**Environmental
Planning
Commission**

**Agenda Number: 2
Project Number: 1005238
Case #s: 14EPC-40032, 14EPC-40033
July 10, 2014**

Supplementary Staff Report

Agent	City of Albuquerque Planning Department
Applicant	City of Albuquerque
Request	Amendment to Map of Coors Corridor Plan Adoption of Rank 3 Coors Corridor Plan The Rights-of-way of Coors Blvd. and Coors Blvd. Bypass and all lots generally located on and/or near Coors Blvd. and Coors Bypass between Bridge Blvd. and Alameda Blvd., containing approximately 2,200 acres.
Legal Desc.	
Current Zoning	Various
Proposed Zoning	No change

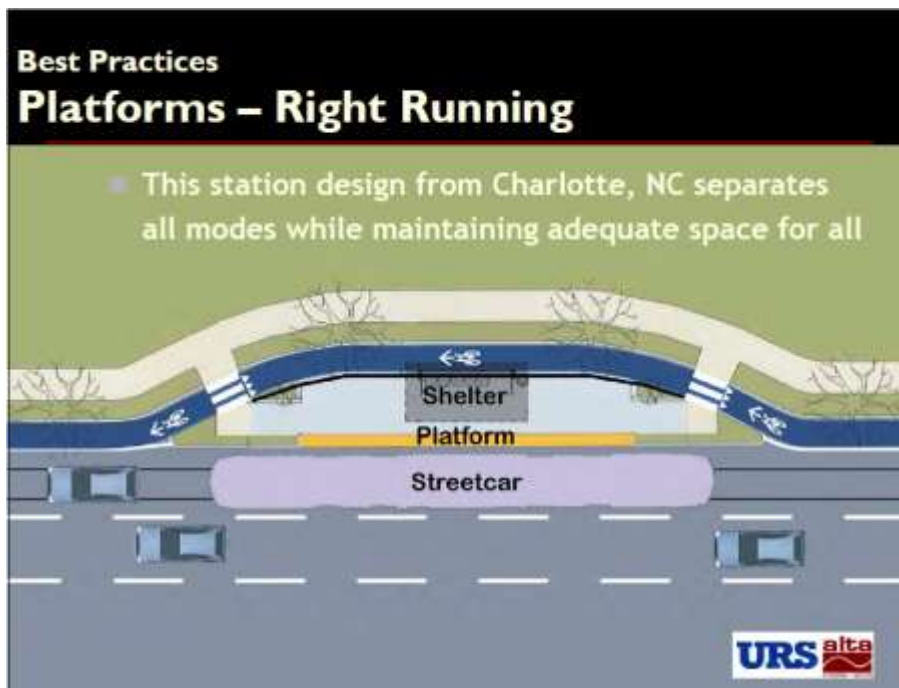
MRMPO's preferred cross section including a cycle track would be ordered:

1. Sidewalk
2. Buffer
3. Cycle track
4. Buffer
5. BRT
6. General auto lanes

At intersections the cycle track would need to meet a mixing zone. There are two typical mixing zones: The first directs the bicyclist to mix with the right-turn-only lane. The second has the cyclist mixing with pedestrian traffic on the adjacent sidewalk. If the right-turn-only lanes are designed so vehicles have to significantly slow down prior to turning right, bicycle traffic could mix in that area. If this is not the preferred roadway design, MRMPO recommends the second, sidewalk mixing option.
